# **Palo Verde Nuclear Generating Station Seismic Hazard Re-evaluation**

NRC Public Meeting  
Rockville, Maryland  
June 9, 2015

Geodetic Extension Rates (in mm/yr) and % of extension that can be explained by fault slip rates

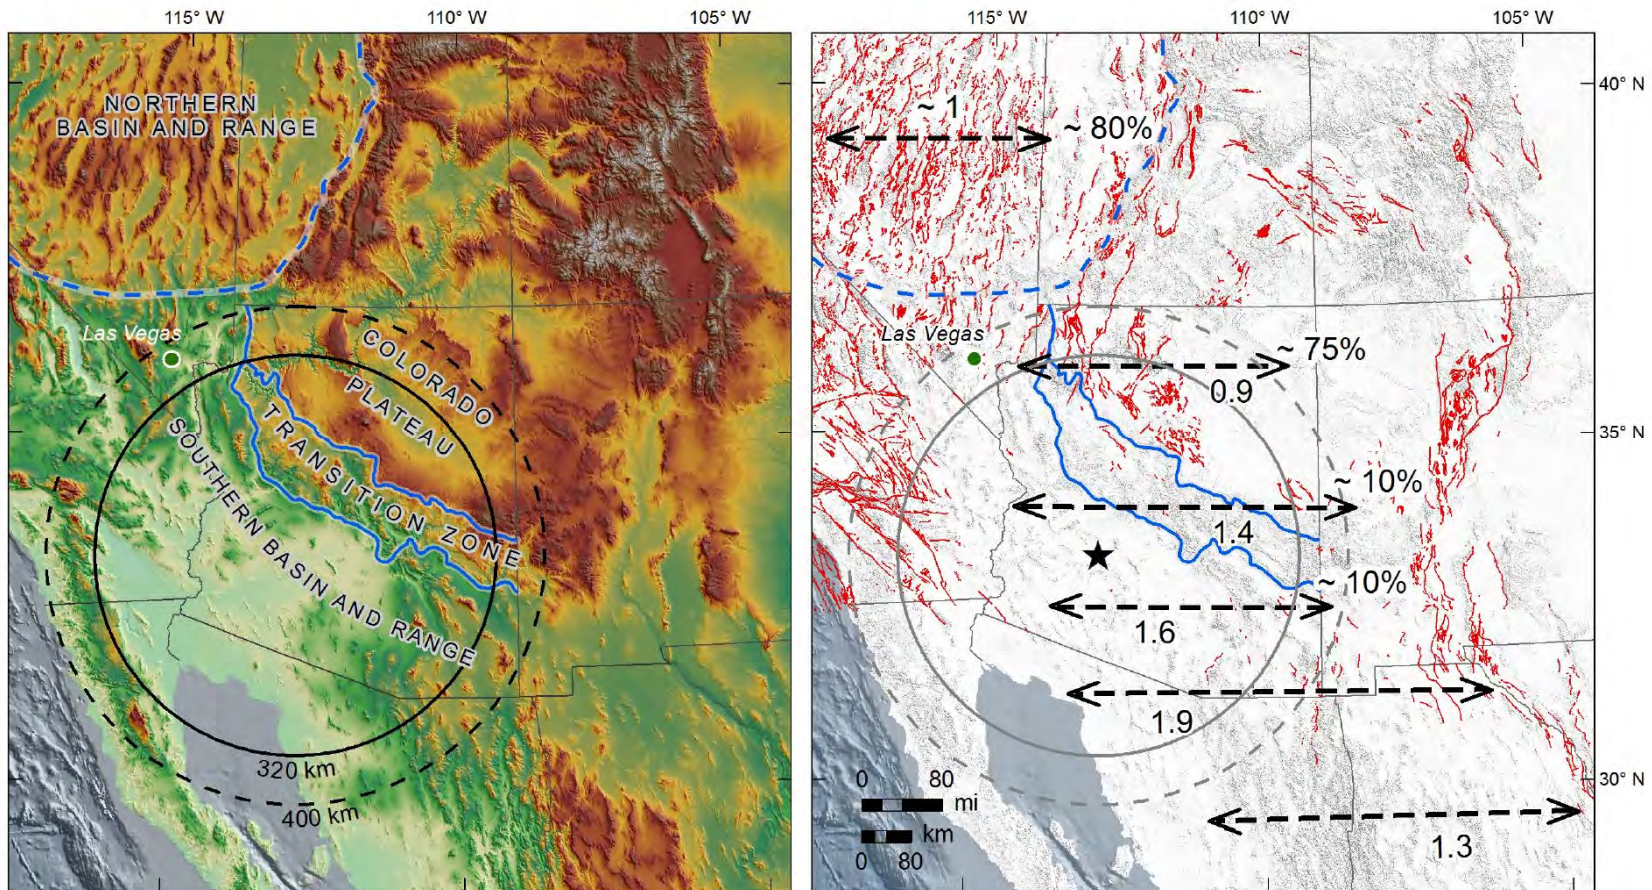
**NRC SSC Q1:** *Provide clarification on how the uncertainty derived from the difference in cumulative slip rates on Quaternary faults in Arizona in comparison to the geodetic slip rates in southern Arizona were evaluated and incorporated into the model. In addition, explain why faults that were originally part of the USGS National Seismic Hazard Mapping Project (NSHMP) and that are now part of the PVNGS SSC include alternative possibilities for geologic and geodetic slip rates while other PVNGS SSC faults that were not included in the NSHMP do not consider geodetic slip rates.*

The differences in geologic and geodetic rates were evaluated in the following manner:

- Obtain E-W geodetic extension rates from Resource and Proponent Expert Corne Kreemer
- Compared to transect in central NV where fault slip rates and geodesy match (Koehler and Wesnousky, 2011)
- Evaluated the likelihood that faults are not expressed geomorphically (How many faults can hide in landscape? At what rates?)
- Evaluated how many faults required to produce geodetic extension rate
- Compared geodetic extension rates to strain rates implied by seismicity in source zones

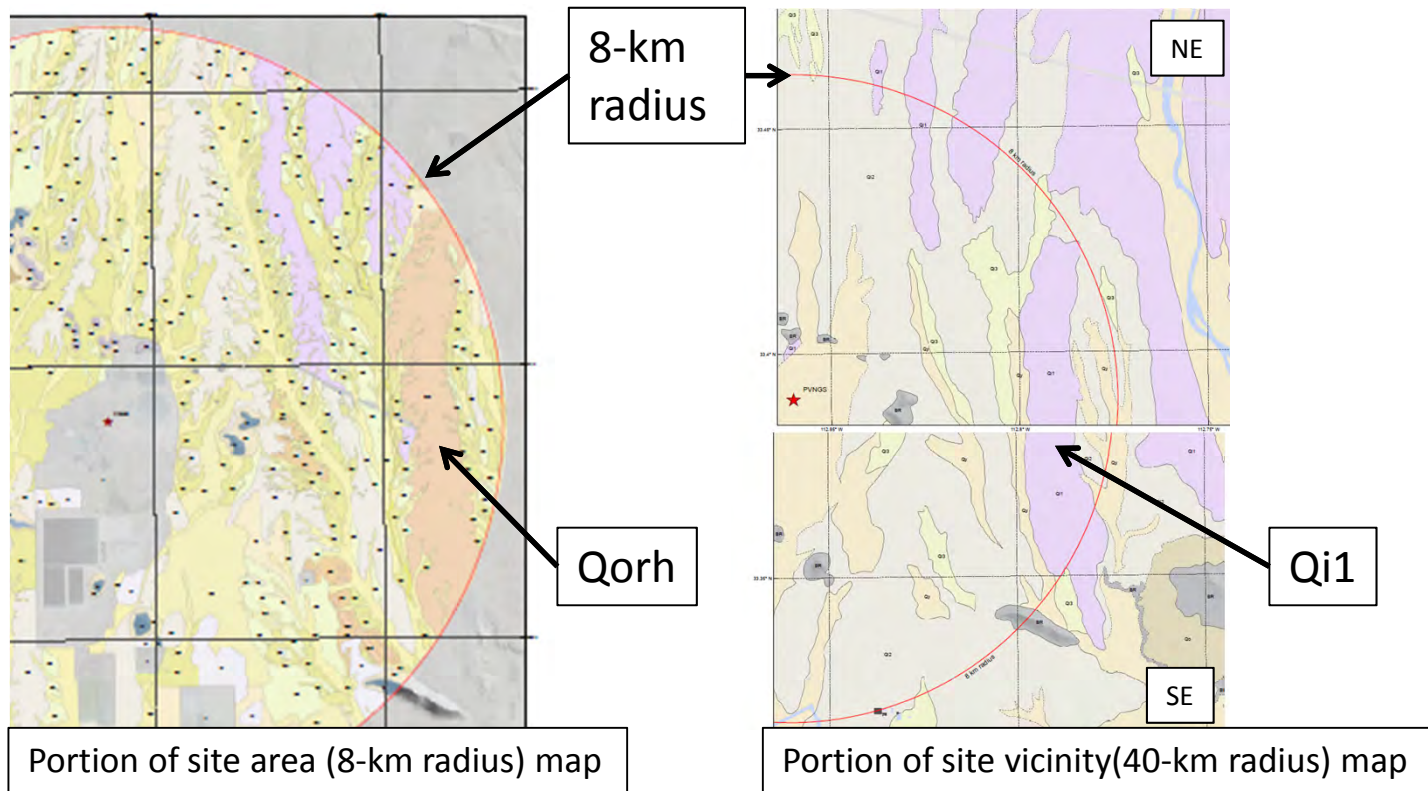
**NRC SSC Q2c:** *explain the apparent mismatch of units between the site area map and the site vicinity map along the north-south trending Qorh river terrace (along the eastern side of the site area map) with the Qi1 alluvial fan surface (to the north and the south of the Qorh unit on the site vicinity map)*

- The 8-km site area map is based on Pearthree et al.'s (2006) mapping of the Wintersburg quad, expanded to cover the entire site area
- The eastern portion of the 40-km site vicinity map is based on 1:100k mapping by the AZGS, modified by Phil Pearthree for this project. The western portion is based on original mapping
- The apparent mismatch between units is a function of comparing maps produced at two different scales with two different levels of detail
  - Simplification and lumping of units in the site vicinity map
  - Site vicinity map does not include small polygons and thin "veneers"

Map showing the PVNGS catalog (color coded by magnitude bin) and Seismotectonic sources

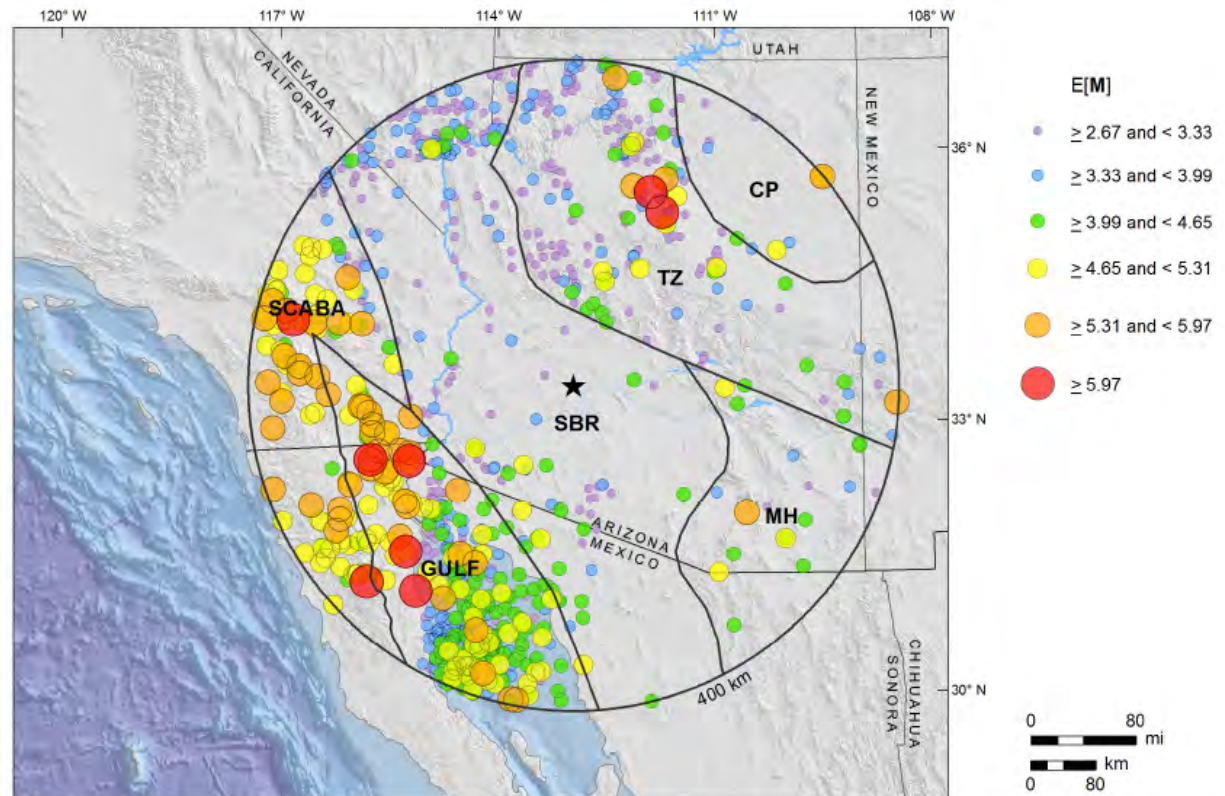
**NRC SSC Topic 3a:** *With respect to the areal source zones, provide the rationale for*

- a. choosing to model the spatial variation of the recurrence rate using variable, but continuous and relatively smooth seismicity rather than using uniform rates similar to the previously completed SSHAC Level 2 PVNGS SSC*

Spatial pattern of earthquakes in SBR source zone is not consistent with the assumption of uniform seismicity

SSC TI Team adopted three alternative sets of magnitude weights, which yield different degrees of smoothness and are consistent with spatial distribution of the catalog data (representing the “center, body, and range” of technically defensible interpretations regarding degree of smoothing)

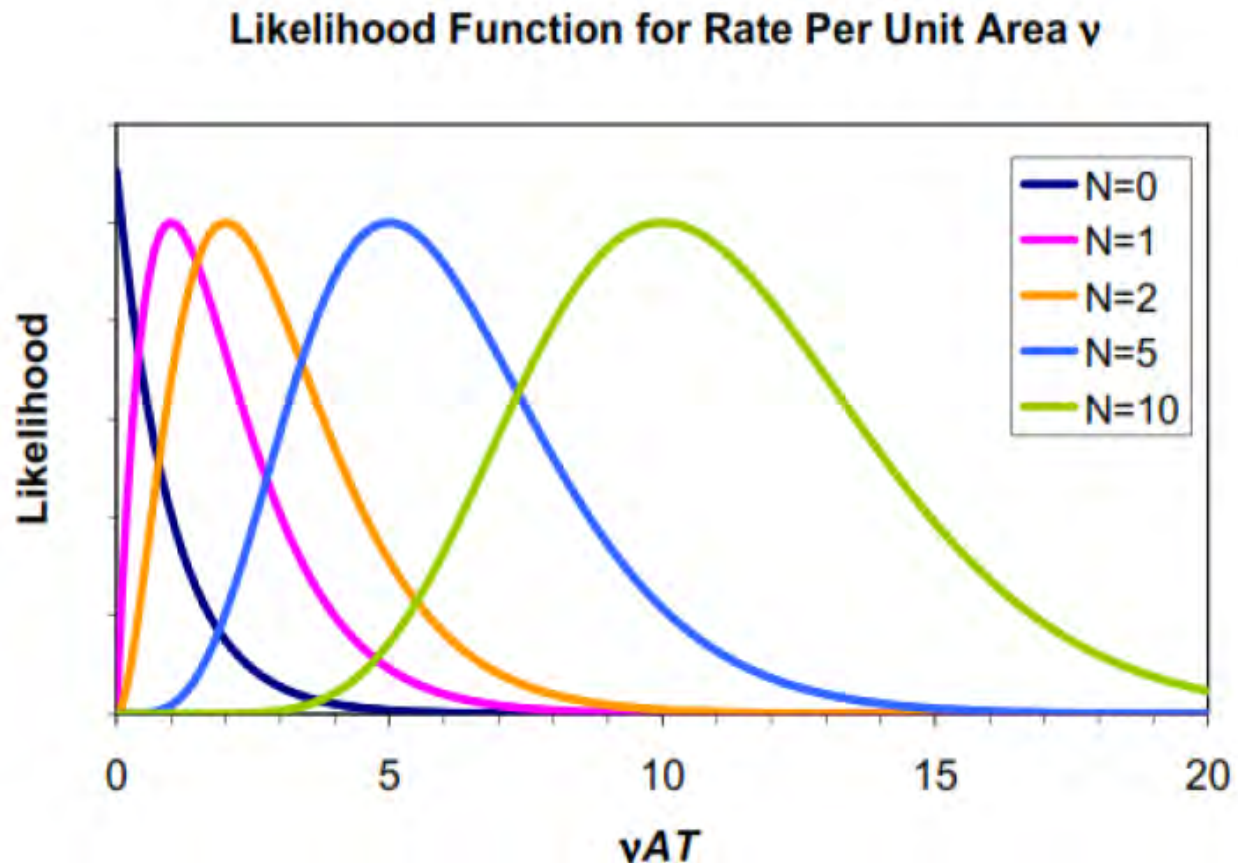
- b. not using a floor during the smoothing analysis of recurrence parameters as the host zones and other zones have cells with a rate of zero*

- The cells with zero rate occur only in alternative realizations of the recurrence maps (as a way to represent uncertainty in rate), **not in the mean recurrence maps**
- The penalized likelihood approach introduces a “natural floor” by modeling the entire likelihood function of the rate

## AS and DS Methods

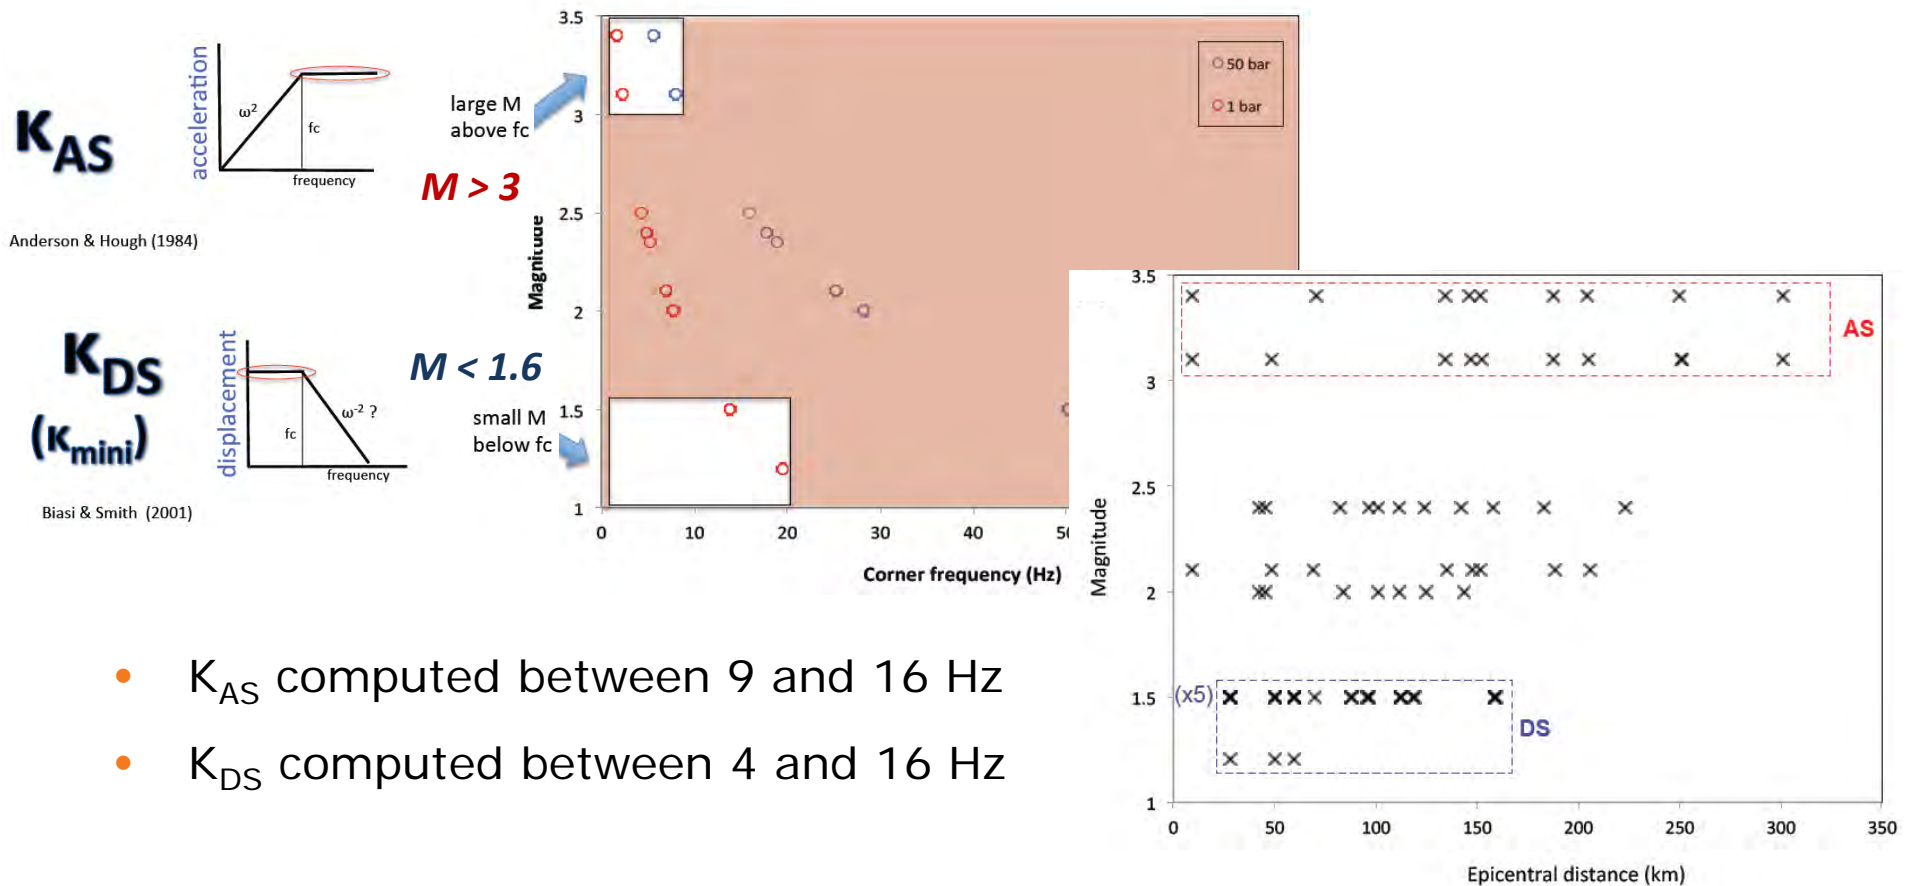
**NRC GMC Q1:** *Considering the limited bandwidth of the data recorded by the TA array, provide additional detail on the process used to estimate the target site kappa values and their uncertainties. In addition, describe in more detail how the site amplification at the recording stations was accounted for in the estimates of site kappa.*

- Combine the two methods to capture uncertainty

- $K_{AS}$  computed between 9 and 16 Hz
- $K_{DS}$  computed between 4 and 16 Hz

## Regional Q Evaluation: Phillips et al. (2013) Model

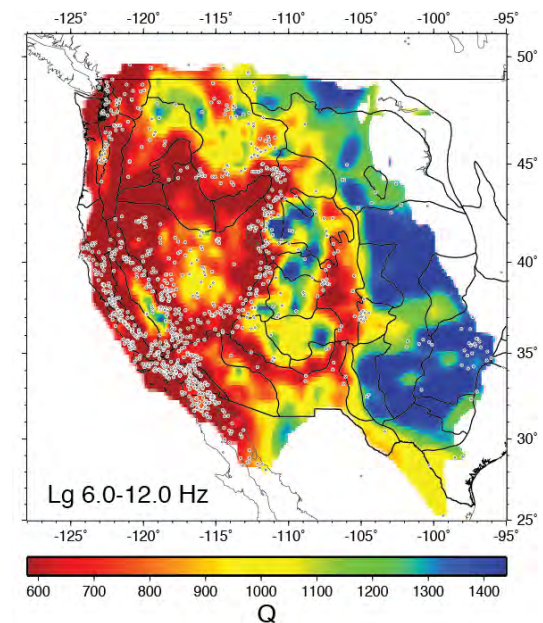
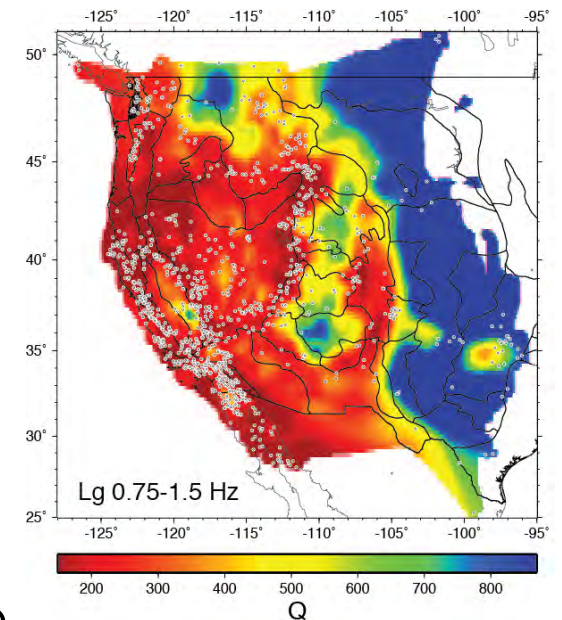
**NRC GMC Q2:** *Provide additional detail regarding the evaluation of candidate GMPEs for PVNGS for distant California and Mexico sources. Specifically, describe in more detail the evaluation of Kishida et al. (2014) of the potential effects of the  $Q$  differences on the ground motions, which provides justification for the conclusion that although there are differences in  $Q$  between California and Arizona, these differences do not lead to a significant discrepancy in the average distance attenuation over the distance range of 200-400 km.*

- Inversion for  $Q$  in individual bands along with moment and corner frequency source parameters
  - $Q(f)$  evaluated at 0.5 deg (50 km) grids
- Higher  $Q$  (lower attenuation) in Arizona (towards mid-west in general) as compared to California
  - Effect more pronounced at higher frequency

## Limitations in Bindi et al. (2014) GMPE

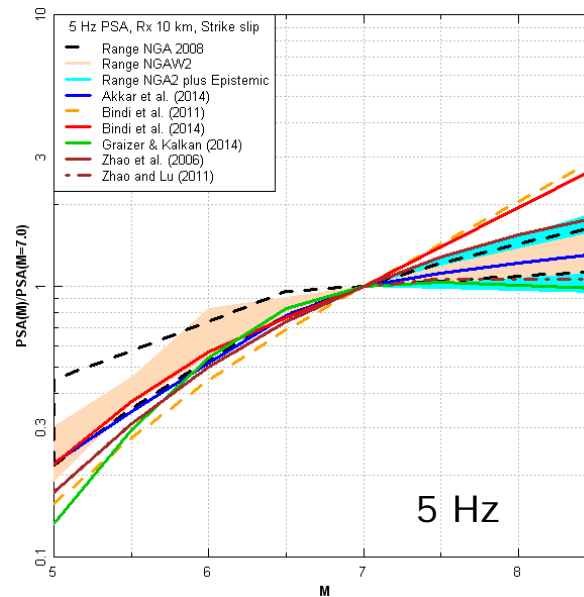
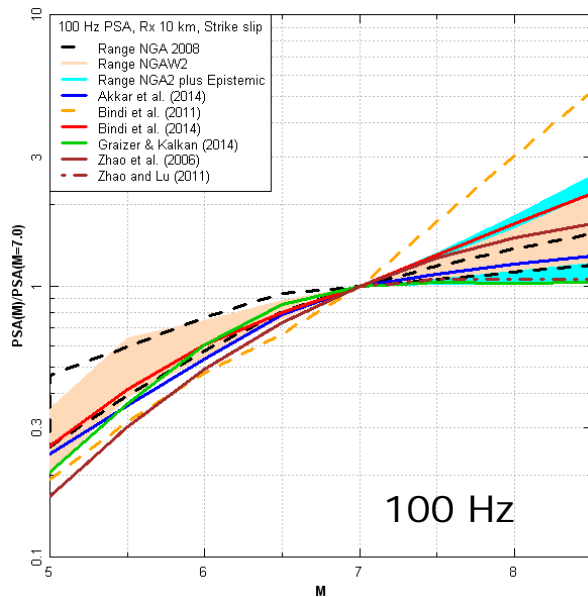
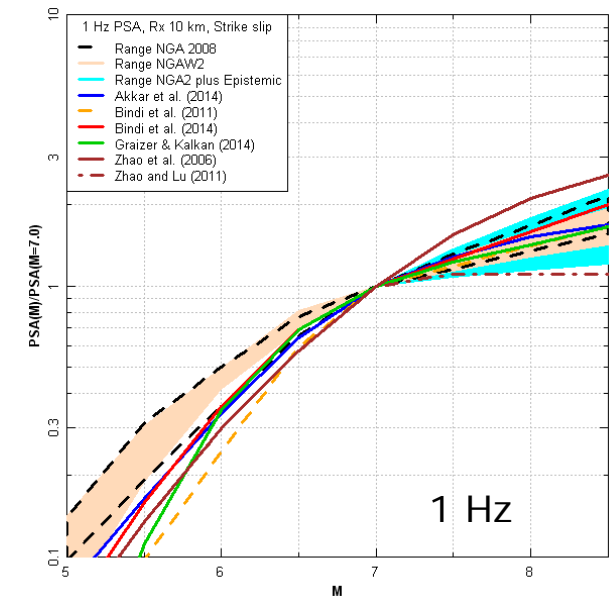
**NRC GMC Q3:** *With regard to the candidate GMPEs for PVNGS for the Greater Arizona Sources, provide additional rationale for limiting the use of the Bindi et al. (2014) for magnitudes greater than M7.*

- Problematic intermediate-frequency magnitude scaling ( $M > 7$ ):
  - Apparent in the 2011 version
  - Resolved for PGA in the 2014 version, but not for 5 Hz
  - Application limited at  $M7$  for all periods

## Common-form Models: Fitting

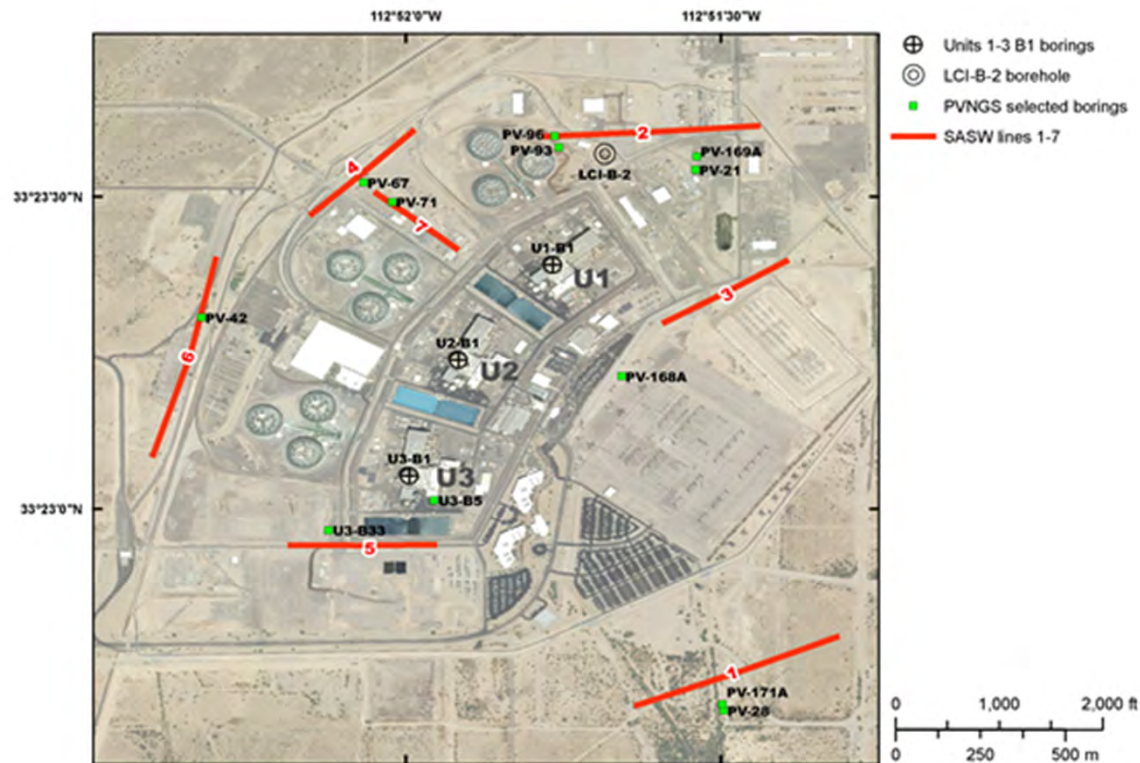
**NRC GMC Q4:** *Provide additional detail on the development of the common function form used to fit the candidate GMPEs. Specifically, please discuss how model parameters such as depth to  $V_s=1$  km/s and 2.5 km/s (which are present in some of the candidate GMPEs) are accounted for in the final functional form.*

- Fitting Process:
  - $V_{S30} = 760\text{m/s}$ , **M**5 to **M**7.5,  $R_x = -200$  to  $18\text{ km}$  ( $R_x > 0$  for  $R_{JB} = 0\text{km}$  conditions), dip of  $\delta = 50^\circ$  (NML events)
  - Site parameters,  $Z_{1.0}$  and  $Z_{2.5}$  are set to their default values for  $V_{S30} = 760\text{ m/s}$  by NGA developers
    - Basin depth is not a significant issue for soft-rock sites
  - HW model added to  $R_{RUP}$ -based common-form models
  - No HW model added to  $R_{JB}$ -based common-form models
